ADDENDUM #4, BID H-24-12
REHABILITATION OF WASTEWATER PUMP STATION NO. 81

PUMP STATION #81 REHABILITATION

DWG No. E.3.0

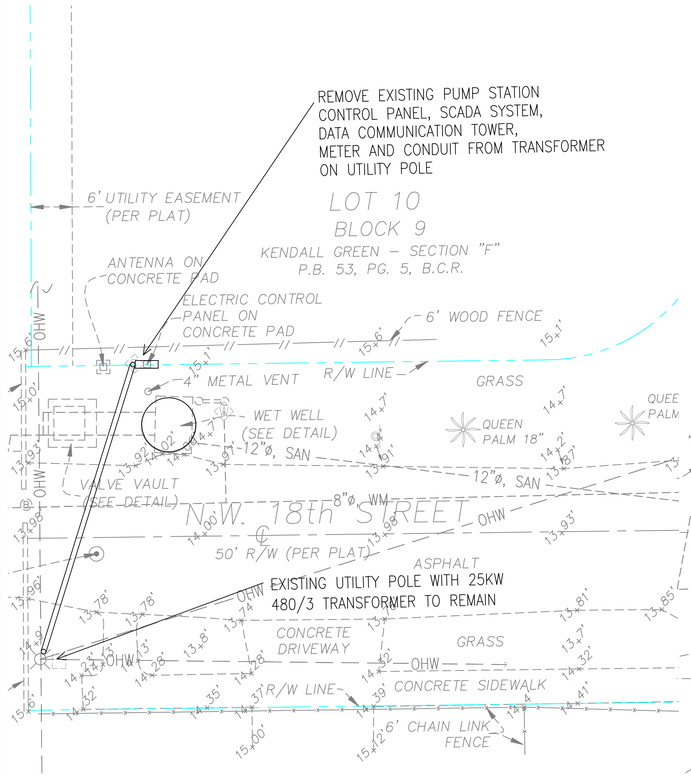
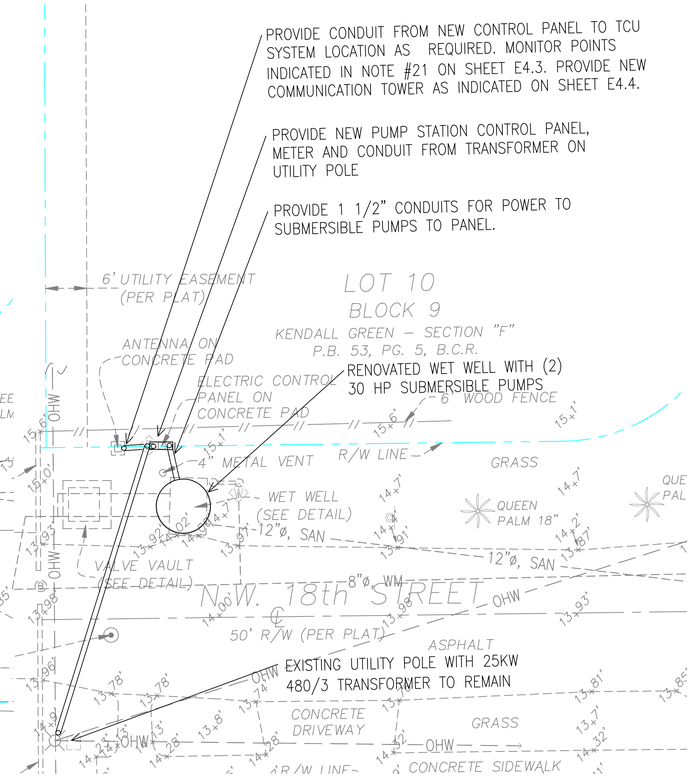
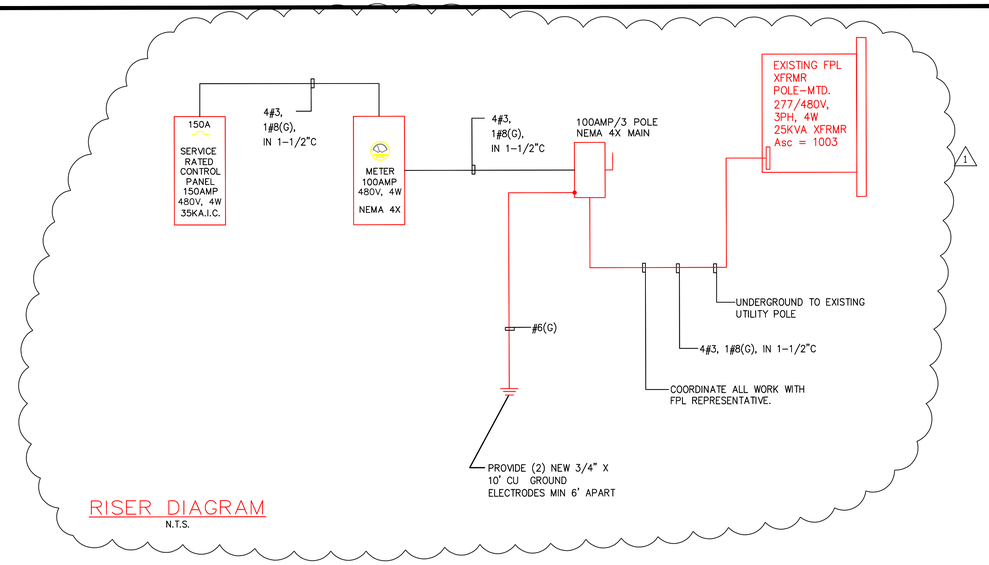
Q20: Drawing E.3 on LS 81 refers to 480 volt transformers to remain on the FPL pole. Electrical riser calls for 120/208 volts. What is the voltage for this site?

Q21: Drawing E.3 also indicates install a disconnect before the meter. If the power is FPL they won't allow a disconnect before the meter.

E3.0 on #81, revised electrical riser and notes on site plans

A20: Voltage for LS-81 is 480v. Voltages indicated on the meter and control panel have been changed to properly reflect this.

A21: Code requires a meter disconnect to be installed ahead of the meter to interrupt service for meter maintenance on 480v services and above. This is not considered the primary service disconnect. This would only be required on LS-81 and not LS-65.

LOCATION REFERENCE for WATEWATER PRESSURE TRANSDUCER

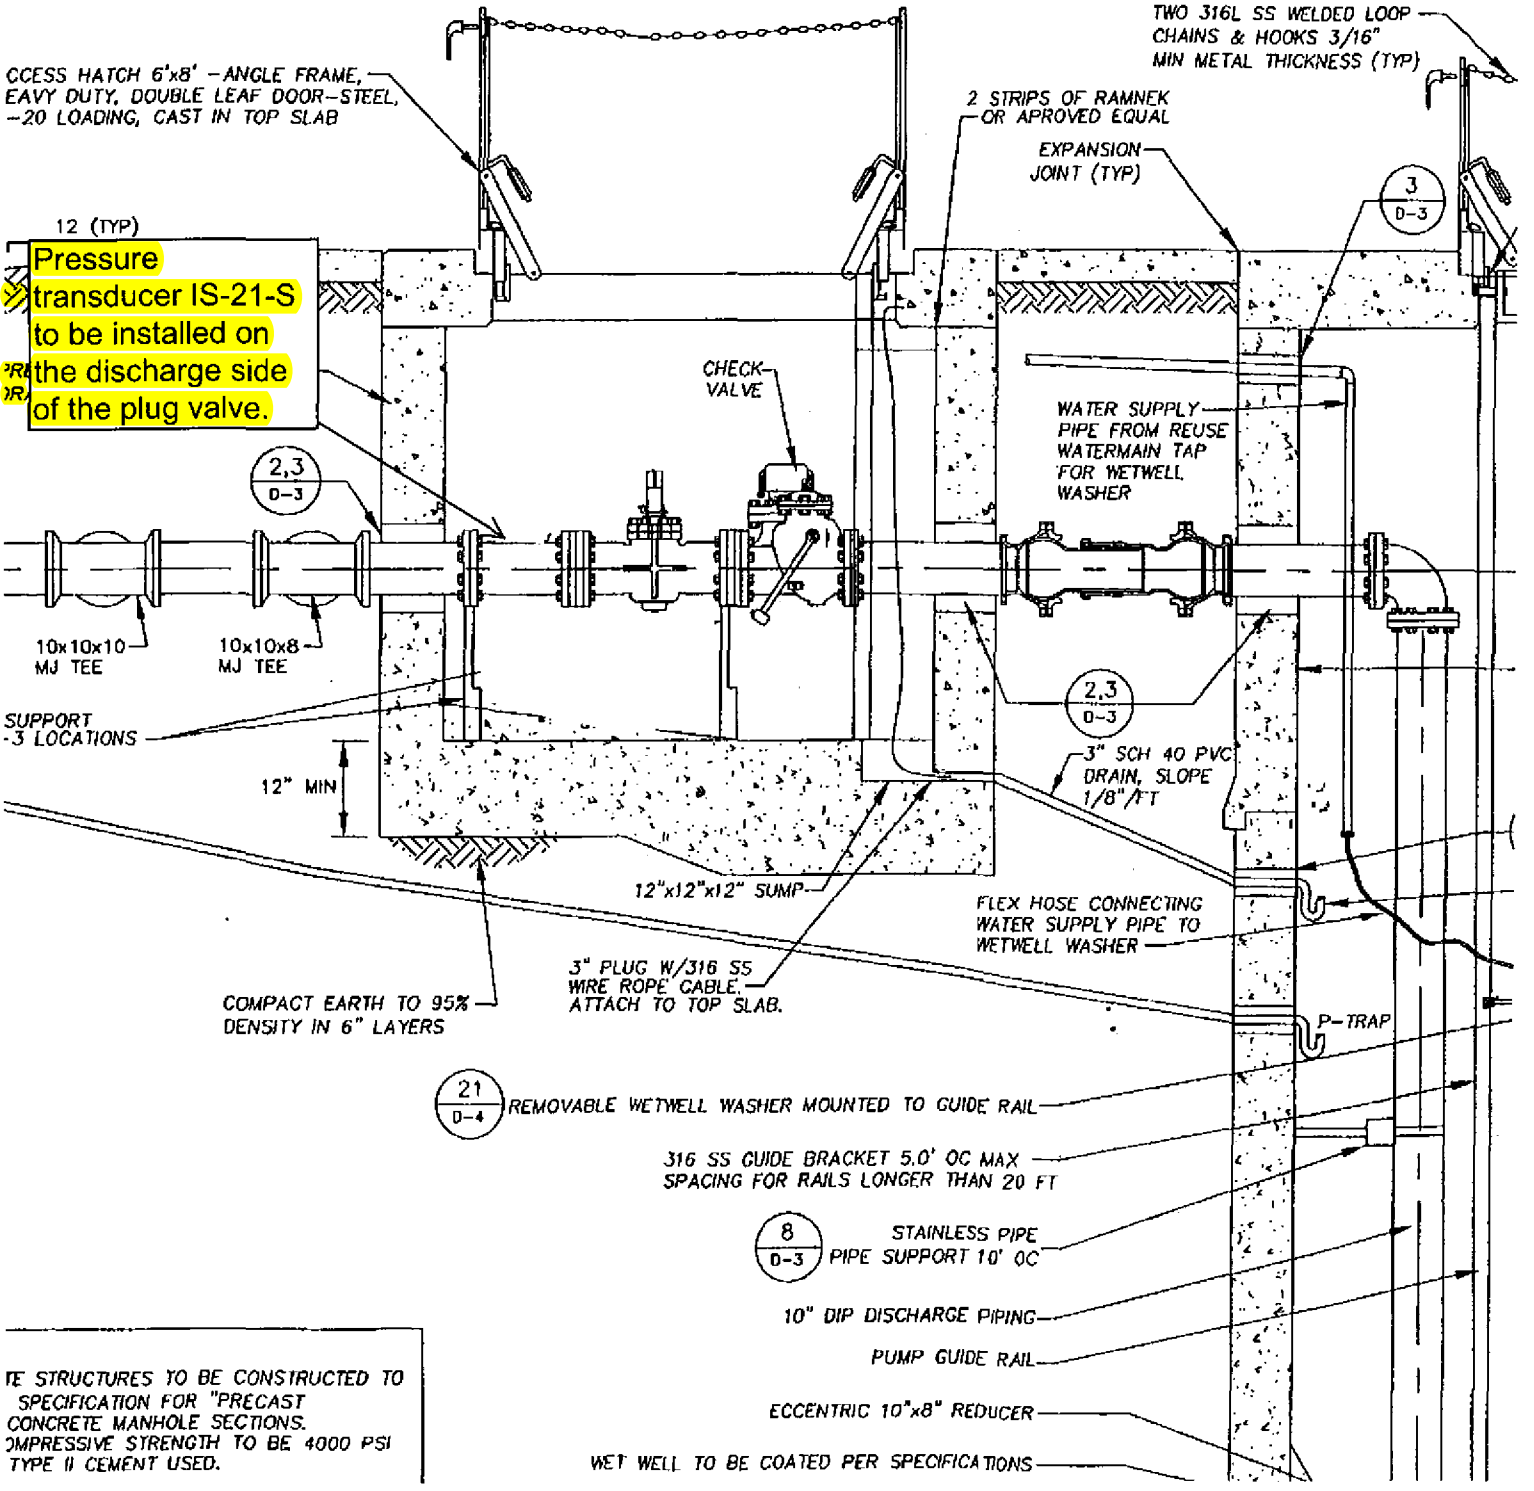
Q5: (Station 81) **Bid Item 26.** Description Furnish and Install Flow Meter with By Pass – We see nothing on the plans or specifications for this bid item.

A5: Bid H-24-12 (Pump Station No. 81) page 17, Bid Proposal form, Item 26., is changed to read "Furnish and install force main pressure transducer" (lump sum). *The description and location for the force main pressure transducer is enclosed with this Addendum. This item has been revised on the bid proposal page; bidders must use the revised bid proposals form.*

IS-21-S, 0-100 PSI transducer to be installed in the valve box. Conduit to be installed to the control panel for connection purposes; the transducer is to be connected via 4-20mA to DataFlow for monitoring purposes. All associated nipples, valves and tee's shall be stainless steel.
